Site: Keenan Properties - 12900 Central SE - L22E061

Re: Drainage Ordinance (14-5-2-1) Violations for Erosion and Sediment Control

Photos are shown below.

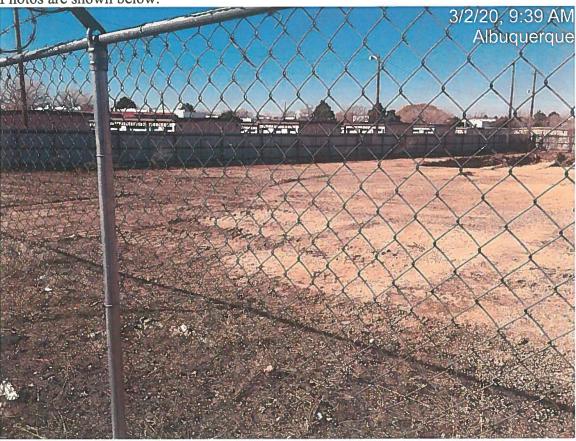
- 1. BMPs were not installed in accordance with the approved ESC Plan.
- 2. NPDES ID was not posted at a publicly accessible location.

- 1. Install and maintain BMPs
- 2. Post NPDES ID and contact information.
